Date: January 5, 2022  
Prepared by: Renee Escario  
To: Jimmy Wong, Associate Planner, City of Santa Fe Springs  
Project: Florence Avenue Townhome Project  
Subject: **CEQA Review of the Proposed Modified Project**

### 3.0 Modifications to the Original Project Description

# Modified Project Site Plan

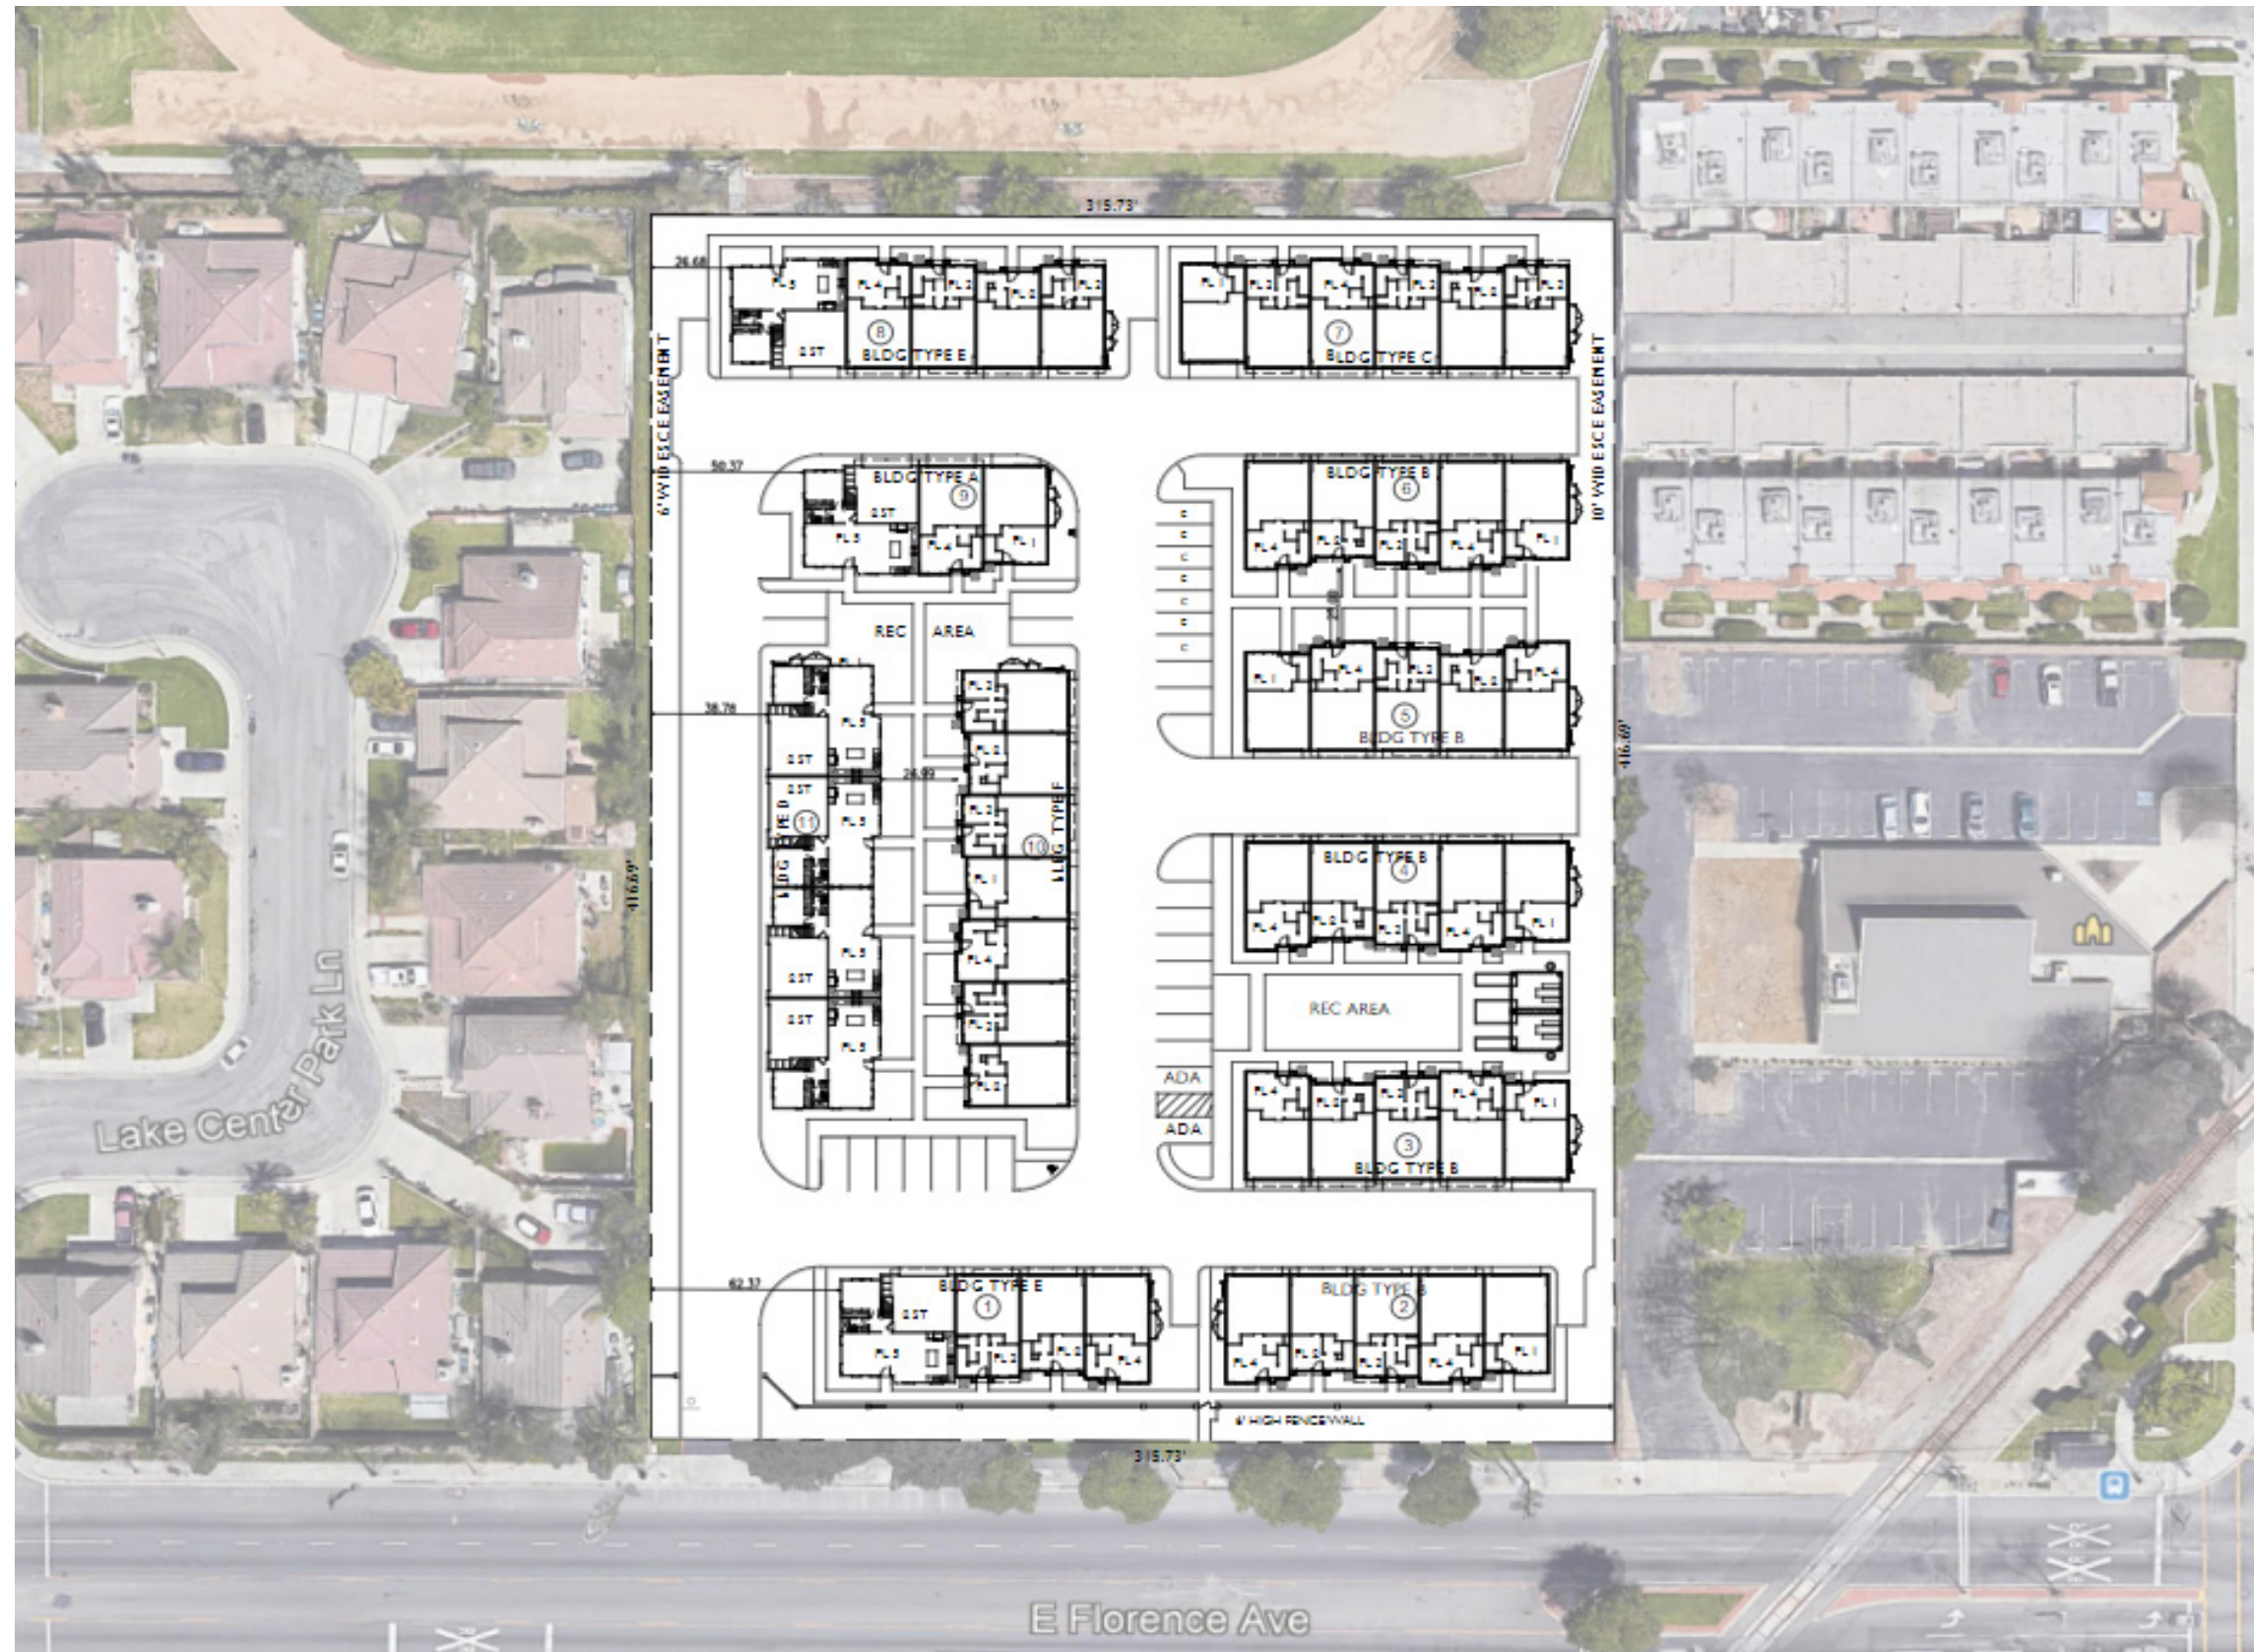
The proposed modified site plan reduces unit count proposed from 63 units to 54 dwelling units, which is a reduction of 9 residential units (a 14.3 percent reduction). The residential structures along the western portion of the site would consist of seven 2-story attached townhomes, adjacent to the existing single-family residences to the west, and the remainder of the site would be developed with 47 3-story attached townhomes. This would result in a reduction in structure height along the western portion of the site from 35 feet to 23 feet 6 inches in height.

The Modified Project would increase the number of open parking spaces on the site from 22 open stalls for 63 residences to 34 open stalls for 54 residences. The open stalls in addition to the attached 2 car garage for each residence would result in a total of 2.63 parking spaces per dwelling unit, which exceeds the Municipal Code requirement of 2 spaces per residence.

The modified site plan results in a slight decrease in lot coverage, a slight increase in the amount of total open space per residential unit, and slight increase in building setback from the western site boundary. All other aspects of the proposed project would remain as originally proposed, including on-site circulation, types of recreation amenities, landscaping, walls, and utility provision. Table 1 provides a comparison between the Original Project as evaluated in the MND and the proposed Modified Project.
